1. PCI Standard Hot-plug Engineering Change Notice – SHPC Extensions for PCI-X 2.0

TITLE:	SHPC Extensions for PCI-X 2.0
DATE:	February 27, 2003
AFFECTED DOCUMENT(S):	PCI Standard Hot-Plug Controller and Subsystem Specification, Revision 1.0
SPONSOR:	Alan Goodrum, Hewlett-Packard, and Sridhar Muthrasanallur, Intel

Figure 3-xx01: PCI-X 266 and PCI-X 533 SHPC Slot Enable Sequence Bus Stabilization Timing, Phase 2

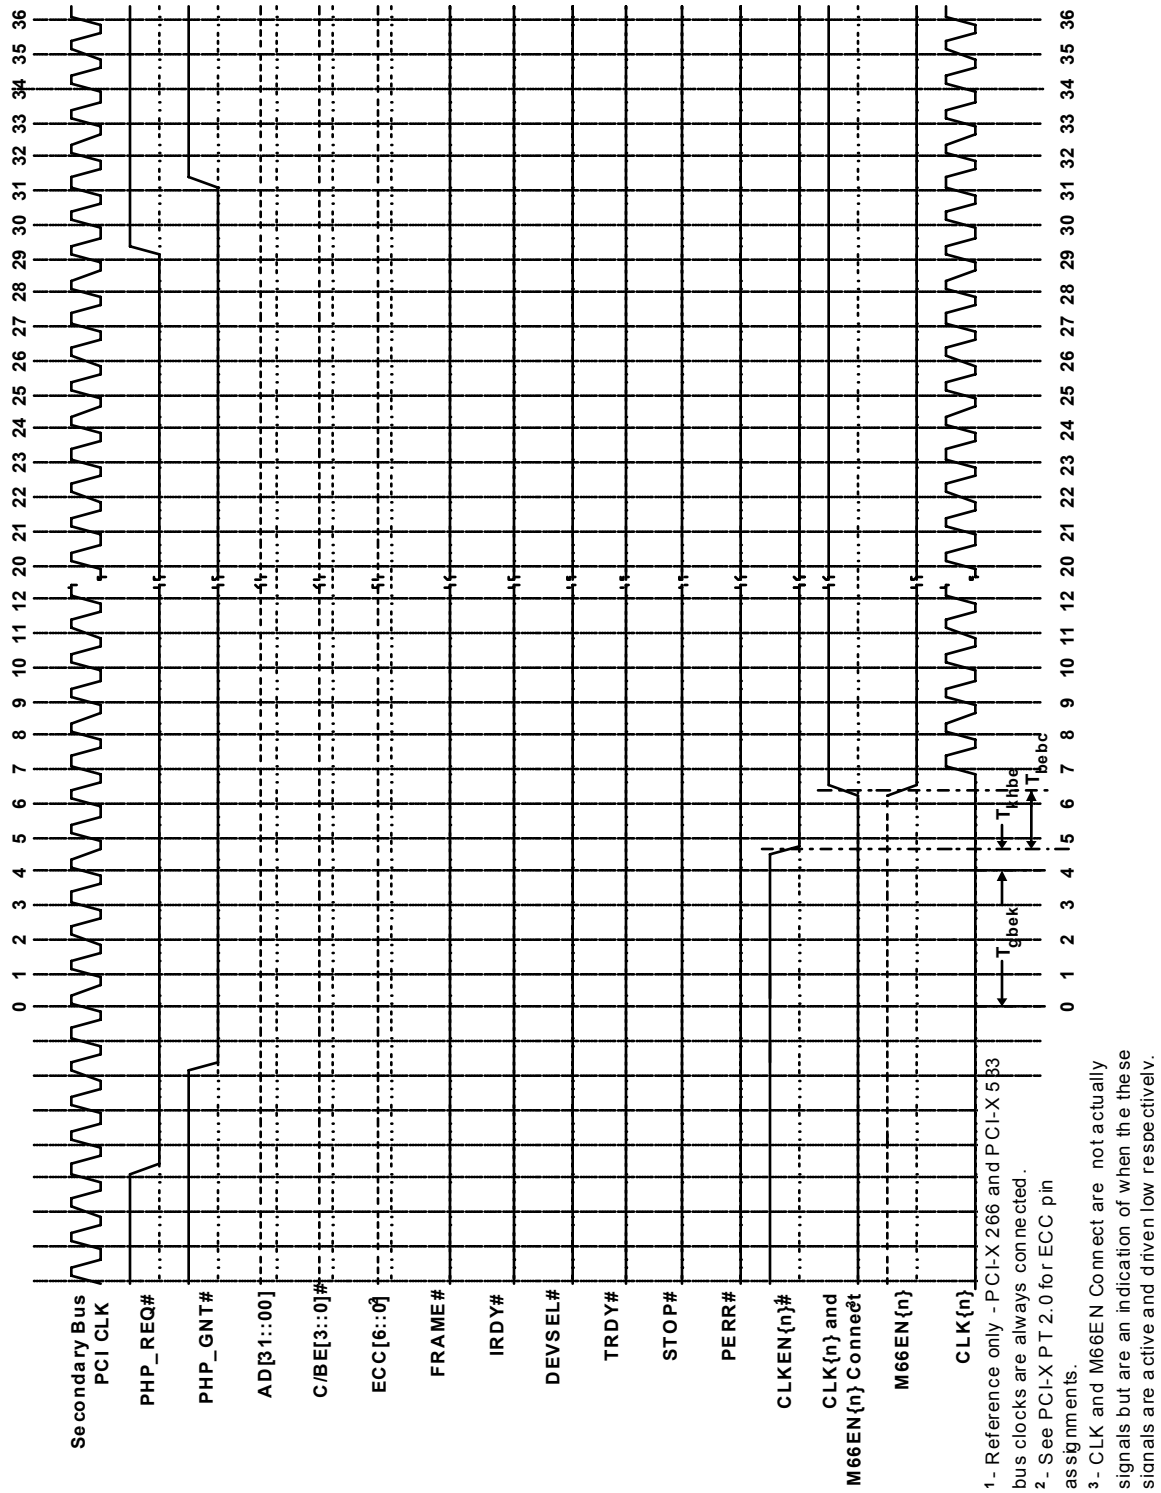
Change Instruction: Add the following figure after Figure 3-6 in Section 3.4.3:

Figure 3-xx02: PCI-X 266 and PCI-X 533 SHPC Slot Enable Sequence Bus Stabilization Timing, Phases 3 and 4

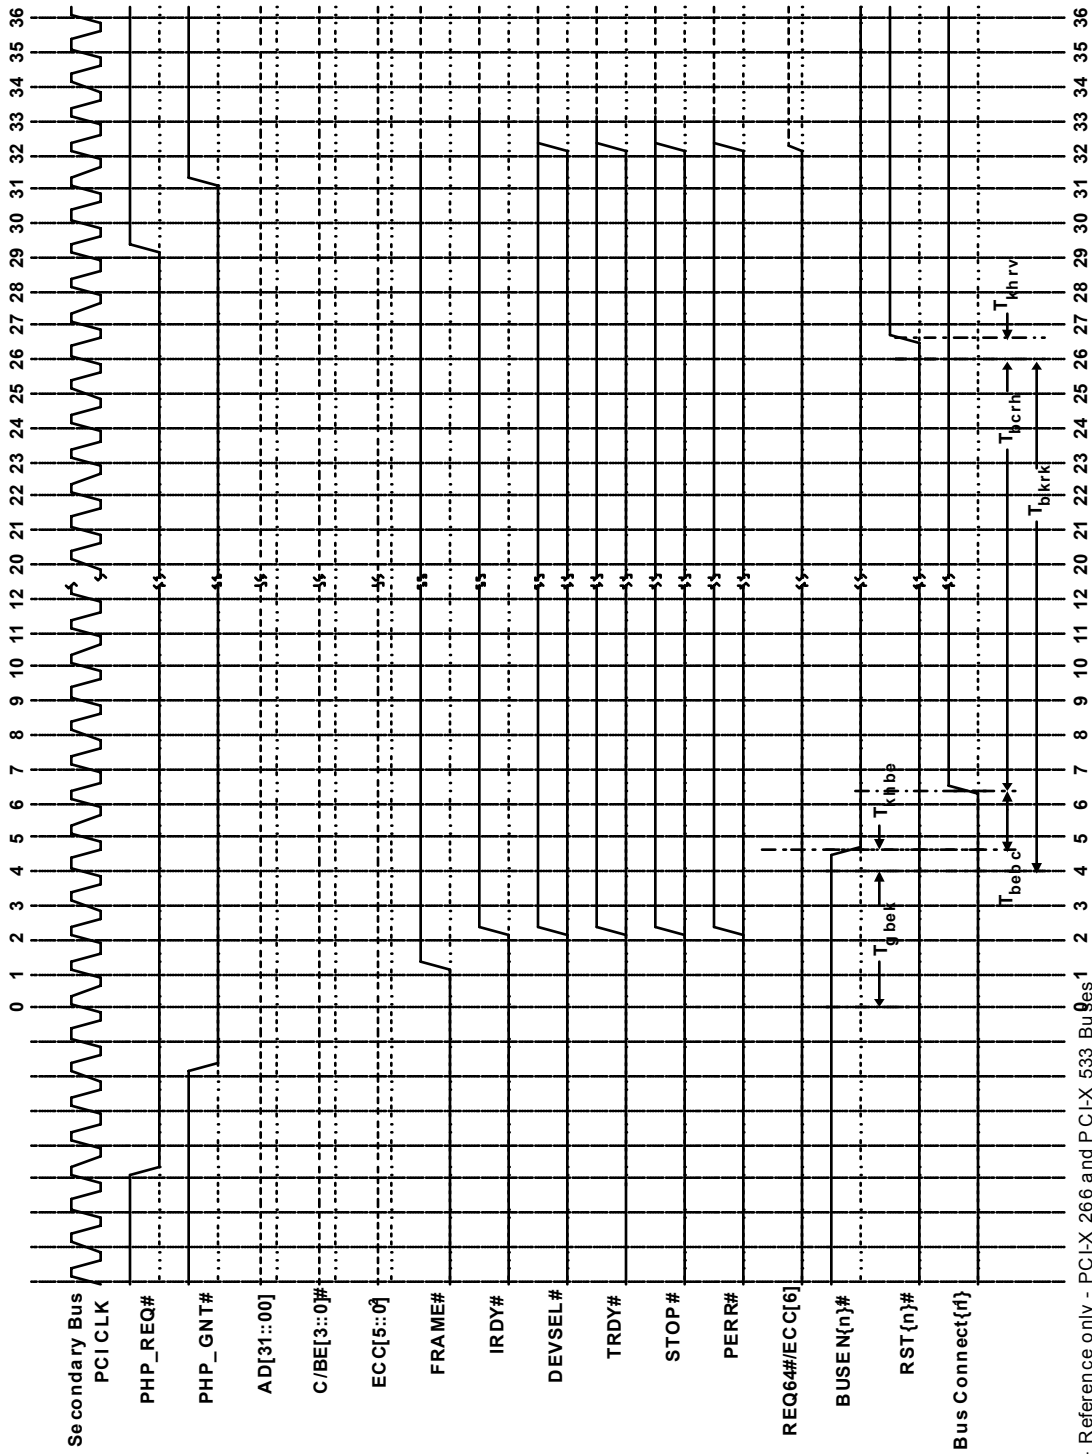
Change Instruction: Add the following figure after Figure 3-8 in Section 3.4.3:

1. Reference only - PCI-X 266 and PCI-X 533 Bus Res1 are always connected.
 2. - See PCI-X PT 2.0 for ECC pin assignments.

**Figure 3-xx04: PCI-X 266 and PCI-X 533 SHPC Slot Disable Sequence Bus Stabilization
Timing, Phase 3**

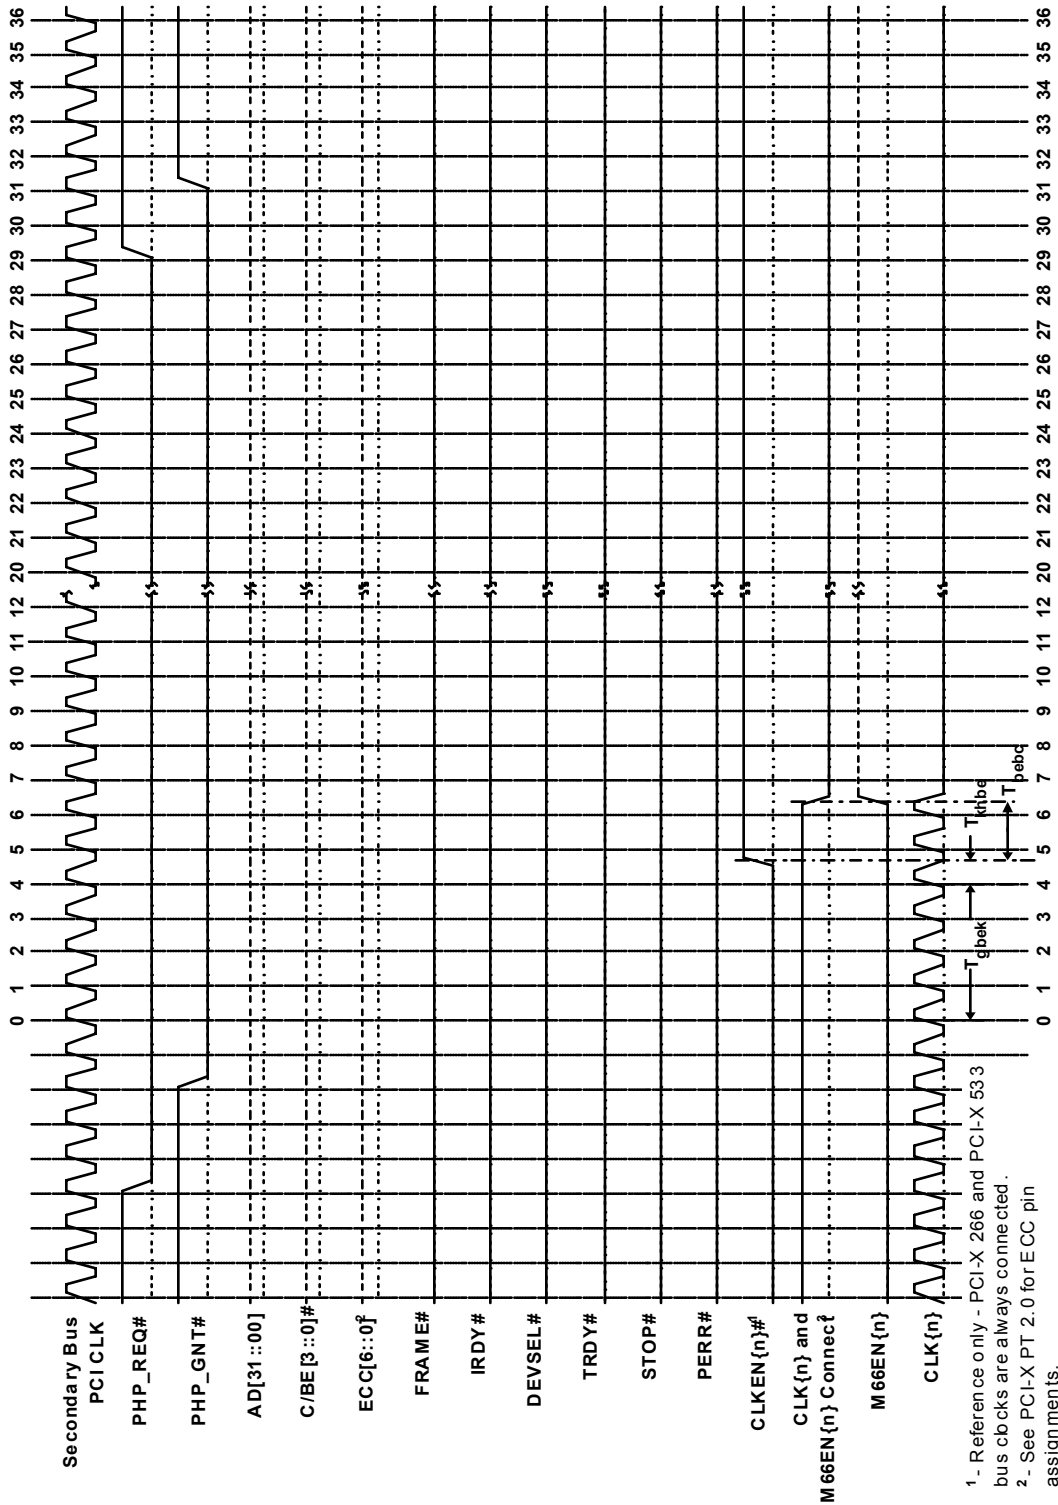
Change Instruction: Add the following figure after Figure 3-13 in Section 3.4.4:

- 1 - Reference only - PCI-X 266 and PCI-X 533 bus clocks are always connected.
- 2 - See PCI-X PT 2.0 for ECC pin assignments.
- 3 - CLK and M66EN Connect are not actually signals but are an indication of when the these signals are driven low and tristated respectively.

Figure 3-xx05: PCI-X 266, PCI-X 533 Mode Deassertion of RST{n}# After a Bus Segment Reset or SHPC Set Frequency/Mode Command

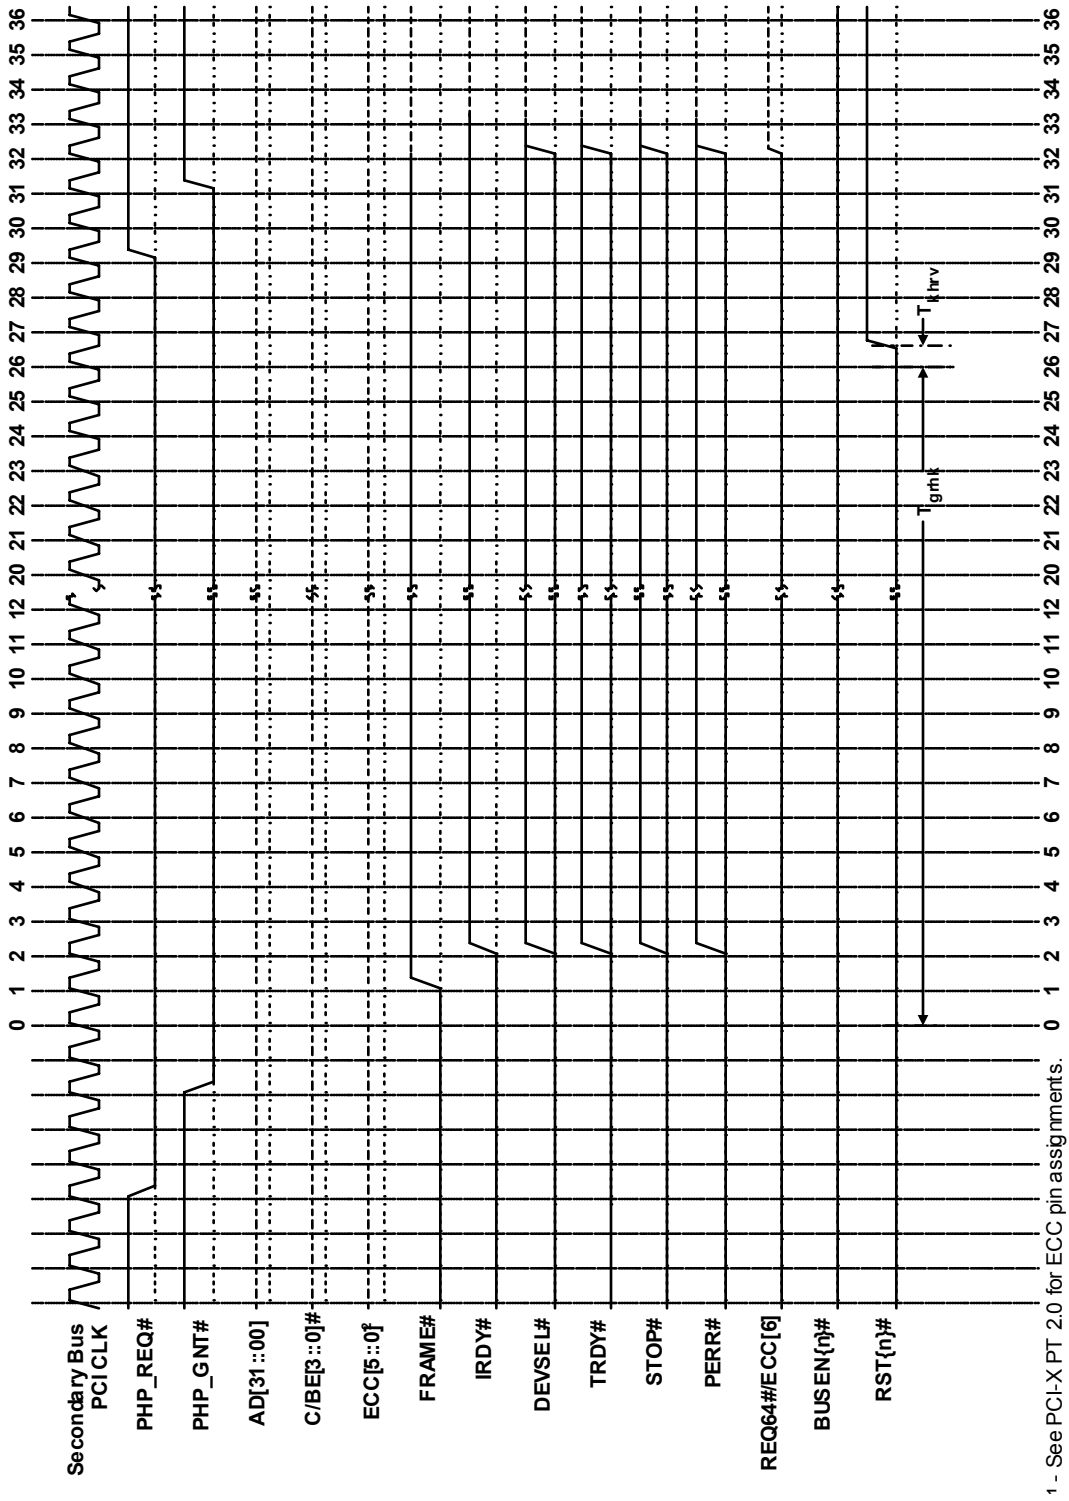
Change Instruction: Add the following figure after Figure 3-16 in Section 3.4.5:

Figure 4-10: Slots Available Registers (I and II)

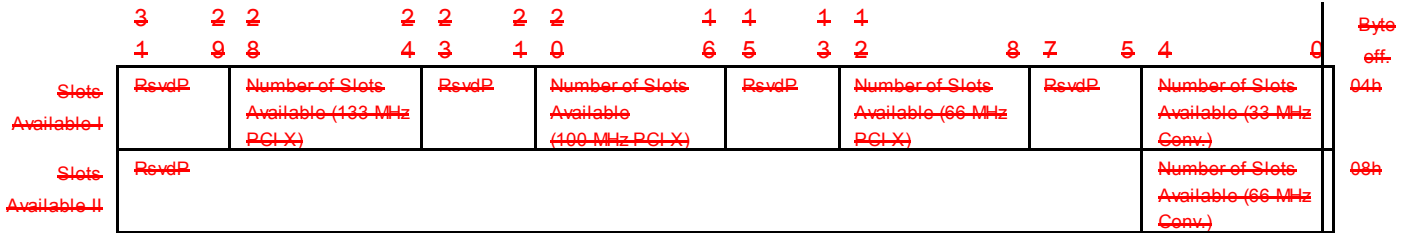
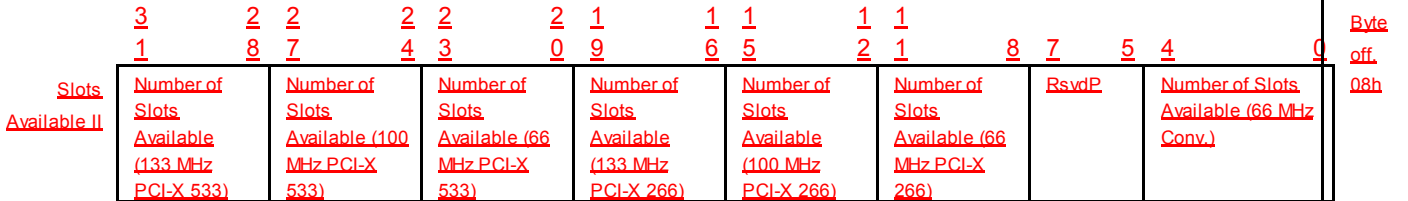
The SHPC contains ~~eleven~~five Number of Slots Available fields organized into two Slots Available registers. Six of these fields correspond to PCI-X 266 and PCI-X 533 operation. Each Number of Slots Available field specifies the maximum number of hot-plug slots that are permitted to be enabled at the given speed and mode on the bus segment associated with this SHPC (see Figure 4-10 and Figure 4-xxxx). This gives the system a way to enforce bus-loading restrictions for different bus speed/mode combinations. For example, a value of 3 in the Number of Slots Available (100 MHz PCI-X) field limits the maximum number of slots that can be enabled on this bus segment to three, when the bus is operating in 100 MHz PCI-X mode. The same system would be permitted to set the Number of Slots Available (66 MHz PCI-X) to 4 indicating a maximum of four slots could be enabled at 66 MHz PCI-X mode. If a bus segment does not support any hot-plug slots at a given speed/mode, the corresponding Number of Slots Available field must be 0.

The register bits 31:8 are only defined as shown, if the SHPC Programming Interface register (PI) is 02h. They are reserved (of type RsvdP) if the SHPC Programming Interface register (PI) is 01h.

Figure 4-12: Secondary Bus Configuration Register

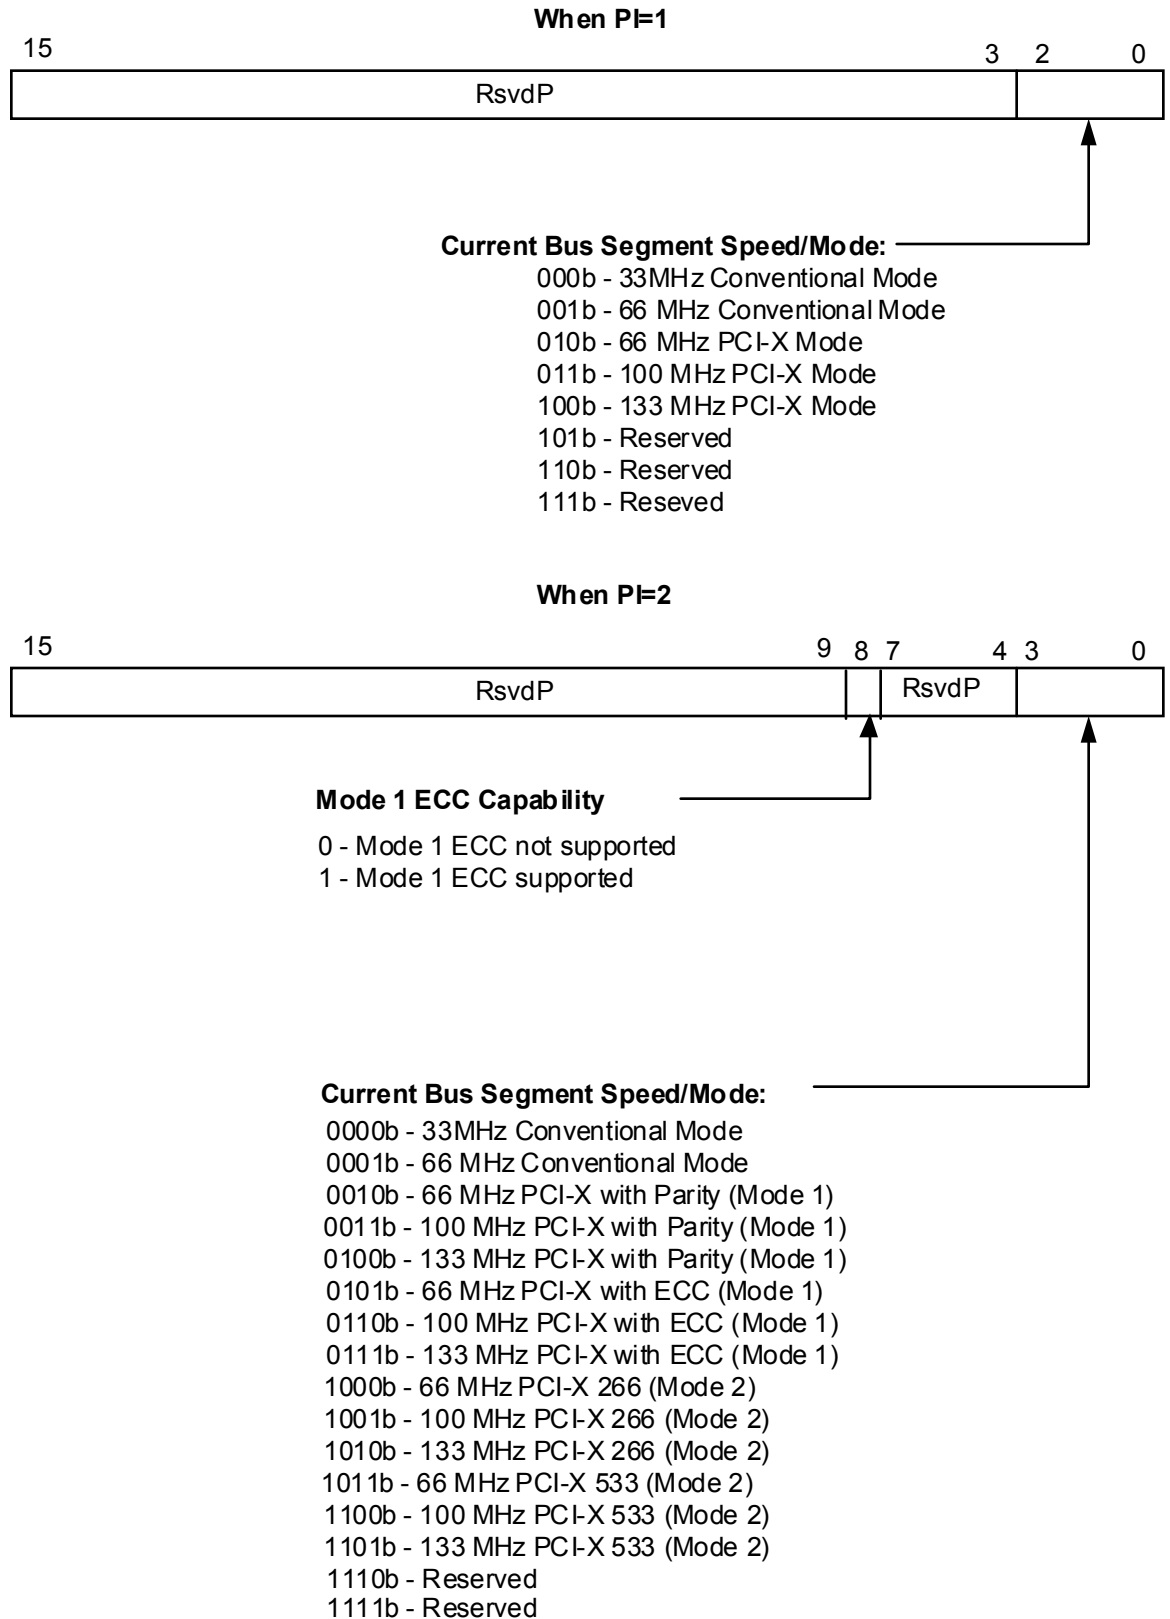
- ~~000b - 33MHz Conventional Mode~~
- 001b - 66 MHz Conventional Mode
- 010b - 66 MHz PCI-X Mode
- 011b - 100 MHz PCI-X Mode
- 100b - 133 MHz PCI-X Mode
- 101b - Reserved
- 110b - Reserved
- 111b - Reseved
